Town of Groveland
Economic Development
Planning & Conservation Department
Planning Board
183 Main Street
Groveland, MA 01834

Board/Committee Name: **PLANNING BOARD**
Date: **TUESDAY, November 19, 2024**
Time of Meeting: **7:00 PM**
Location: **Town Hall 183 Main Street
Groveland, MA 01834**
Signature: *Annie Schindler*

CONTINUED 181R SCHOOL STREET:

A hearing in accordance with M.G.L. Chapter 41, Section 81T, the Town of Groveland Subdivision Rules and Regulations and Article 14 of the Groveland General Bylaws, to hear the application of Groveland Redevelopment LLC. c/o Louis Minicucci Jr, 231 Sutton St, Suite 1B, North Andover MA 01845, requesting approval of a six (6) lot Definitive Subdivision Plan labeled 181R School Street, Groveland, Massachusetts and associated Stormwater Management & Land Disturbance Permit. The site is located in the Residential 2 (R-2) Zoning District. The proposed subdivision is located at 181R School Street Groveland, MA 01834. (Assessors Map 34, Parcel 13).

REVISIONS			GRADING & DRAINAGE	DRAWING NO. C-6
NO.	DESCRIPTION	DATE		
1	PER PEER REVIEW	11/5/24

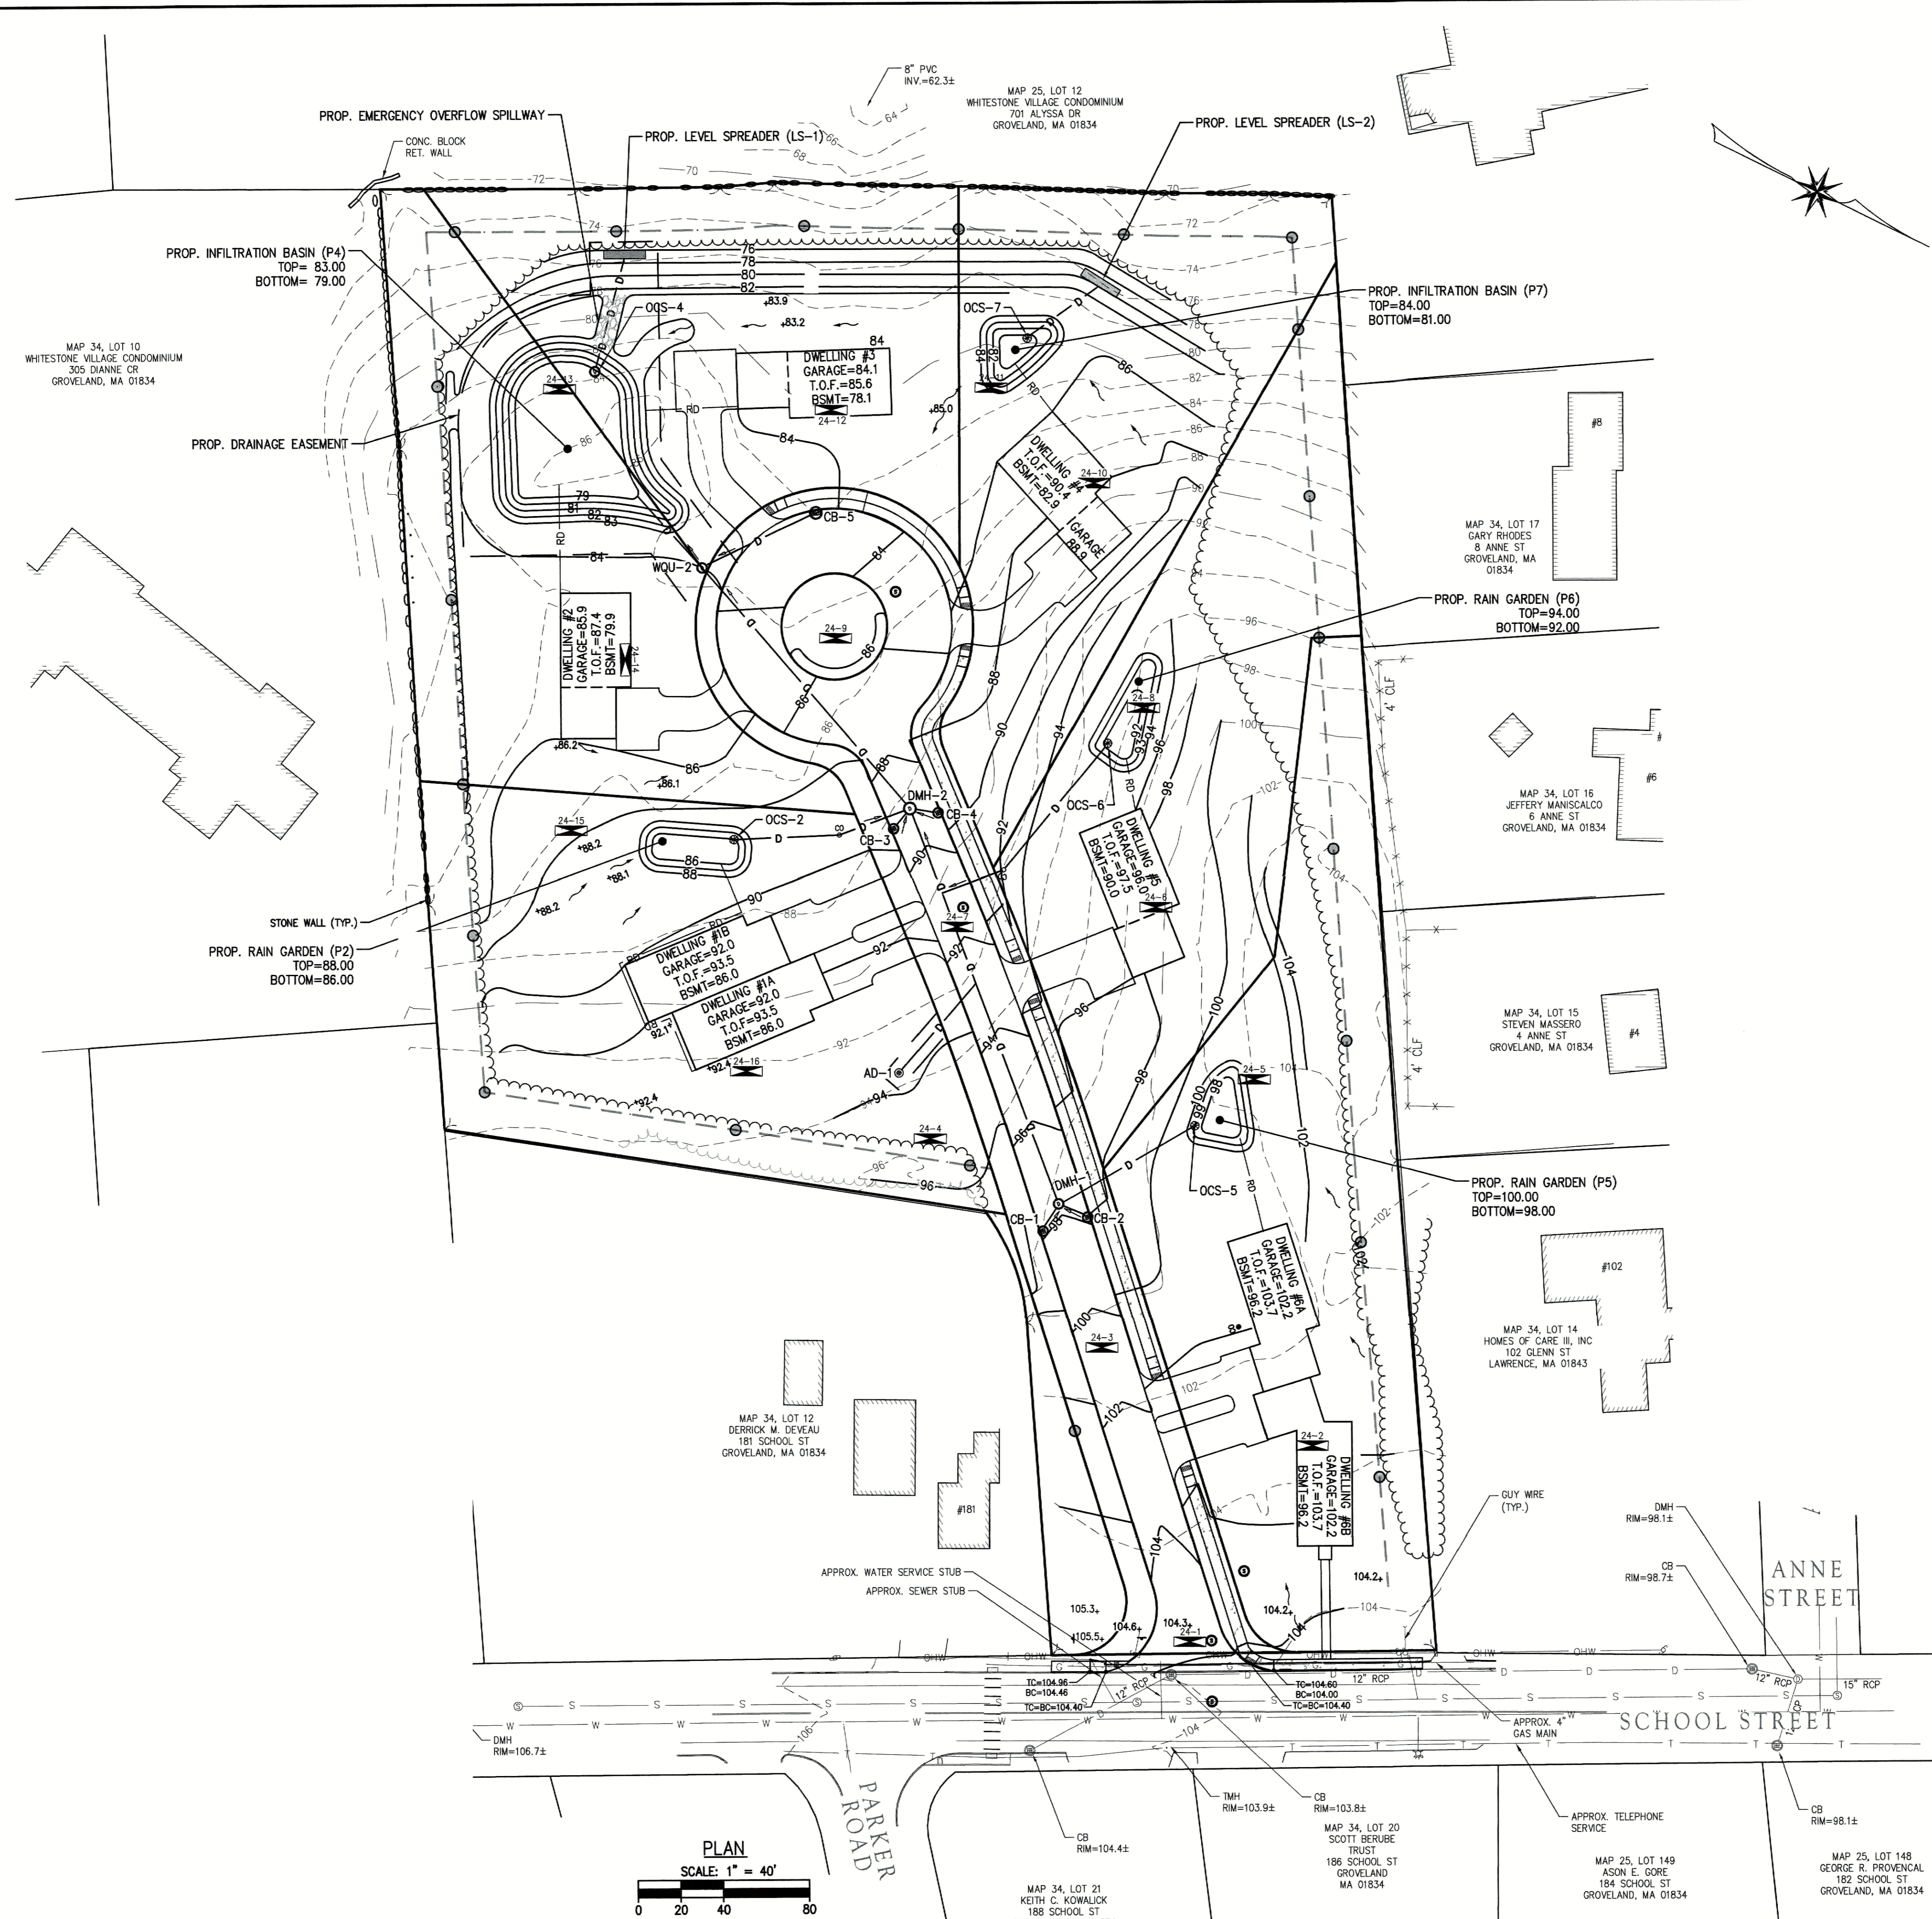
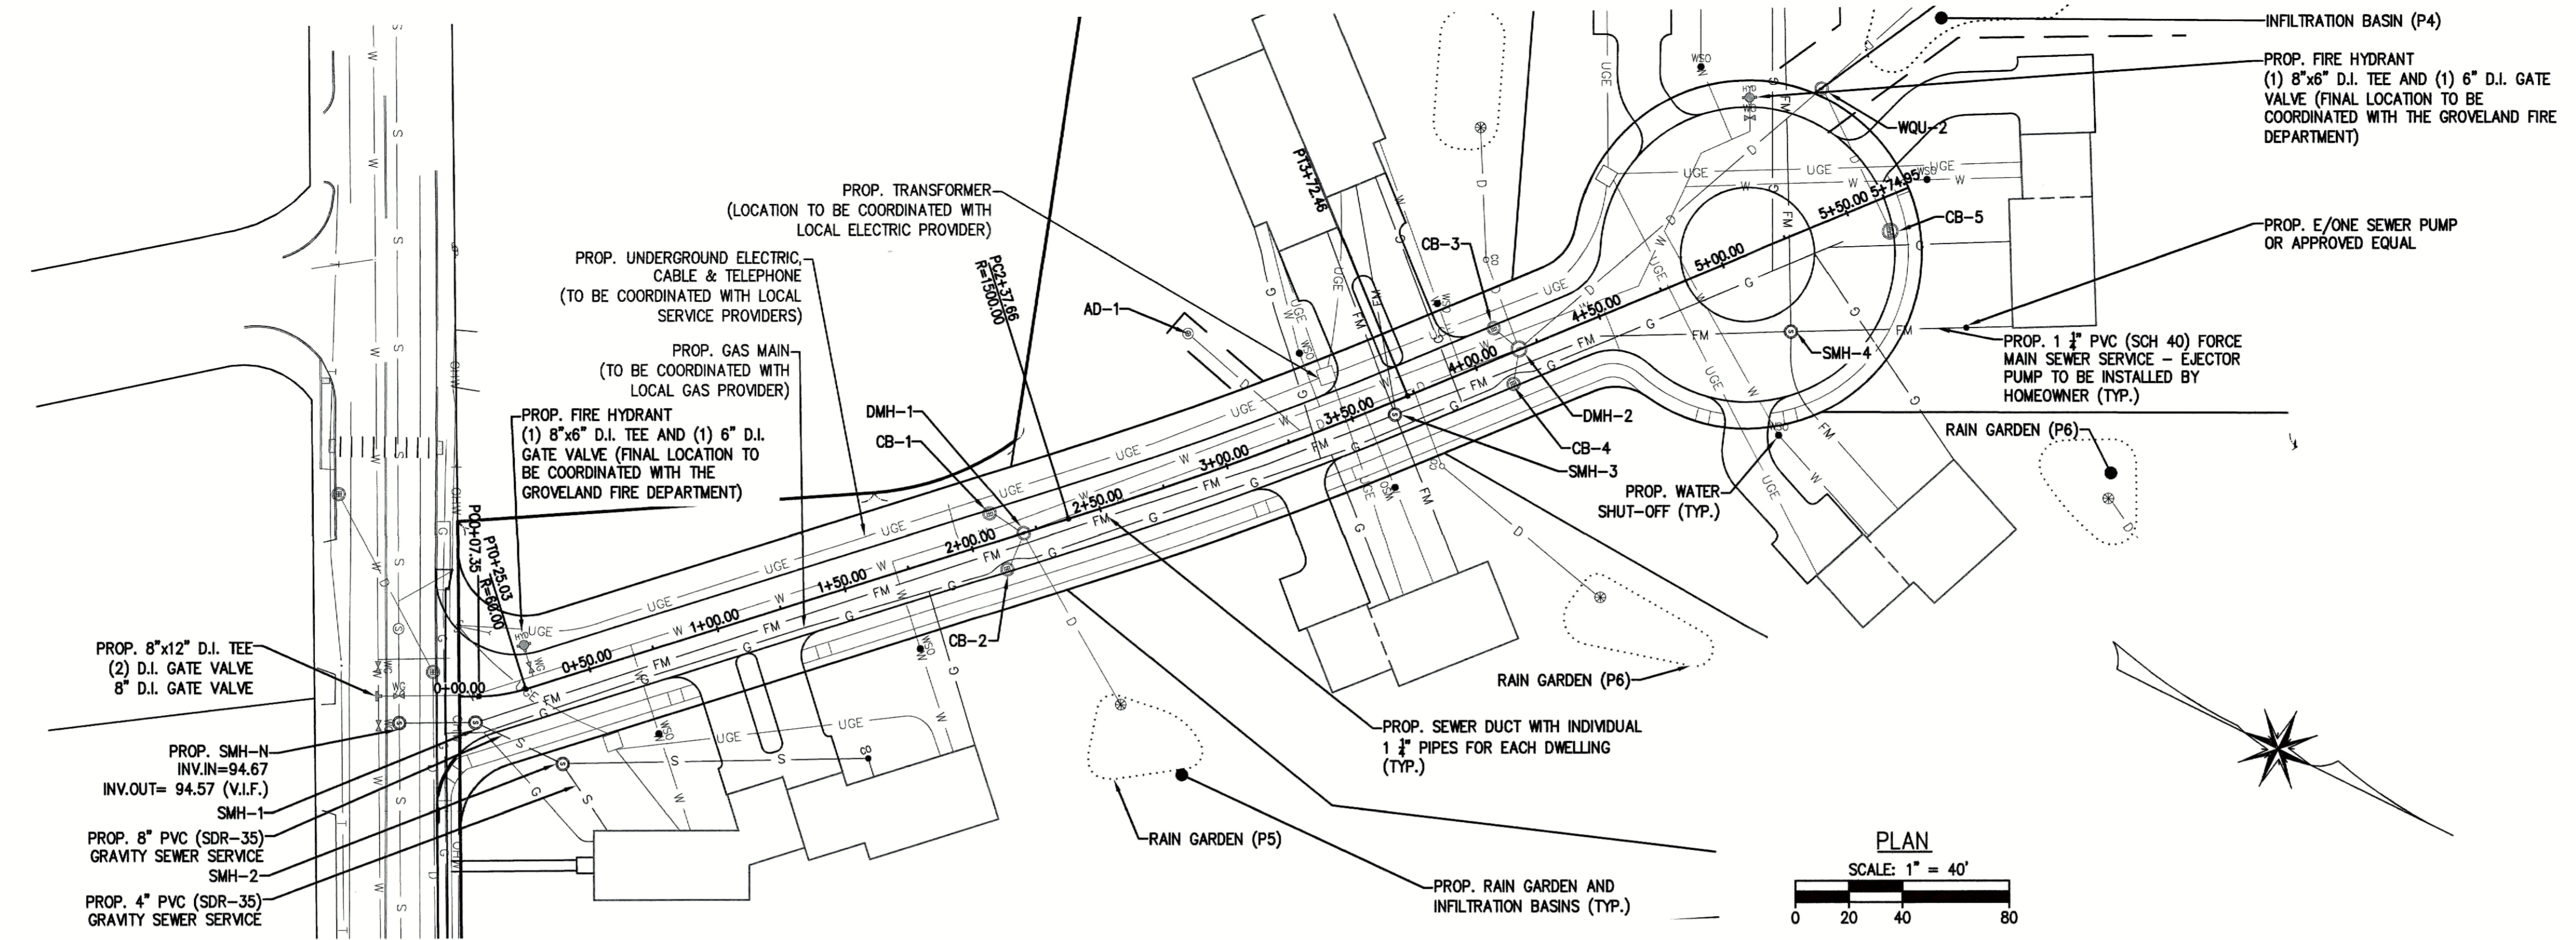
- d. *On Sheet C-7, there is no label detailing the proposed rim or invert elevation(s) for proposed catch basin 2 (CB-2).*

- e. *On Sheet C-7, water quality unit 2 (WQU-2) appears to have pipe inverts leaving the structure that are higher than the inverts in.*

24. **TEC Comment:** *No rim elevation is provided for SMH-1.*
MCG Response: The profile has been updated to include rim and inverts elevation for SMH-1. See Sheet C-7.

25. **TEC Comment:** *Pipe sizing and proposed material type should be provided for the proposed sewer connection from Lot 6.*
MCG Response: The plan has been revised to include the pipe size and material for lot 6. See Sheet C-7.

26. **TEC Comment:** *Two utility conflicts can be observed on Sheet C-7:*
 - a. *SMH-3 appears to be in the middle of the proposed drainage line connection, between Rain Garden P5 and DMH-1.*

- e. On Sheet C-7, water quality unit 2 (WQU-2) appears to have pipe inverts leaving the structure that are higher than the inverts in.

26. Two utility conflicts can be observed on Sheet C-7:

- a. SMH-3 appears to be in the middle of the proposed drainage line connection, between Rain Garden P5 and DMH-1.
 - b. The forced main connection between SMH-4 and the Lot 2 dwelling appears to conflict with the drainage line between DMH-2 and WQU-2.
- a. **MCG Response: The plan has been updated to move SMH-3 away from P5 and DMH-I. See Sheet C-7.**
- b. **MCG Response: The proposed force main connection crosses under the drain line, but a vertical separation of 1.5 ft.**

MCG Response: The plan has been updated to move SMH-3 away from P5 and DMH-1. See Sheet C-7.

MCG Response: The profile has been updated to include rim and inverts elevation for SMH-1 . see Sheet C-7.

MCG Response: The plan has been revised to include the pipe size and material for lot 6. See Sheet C-7.
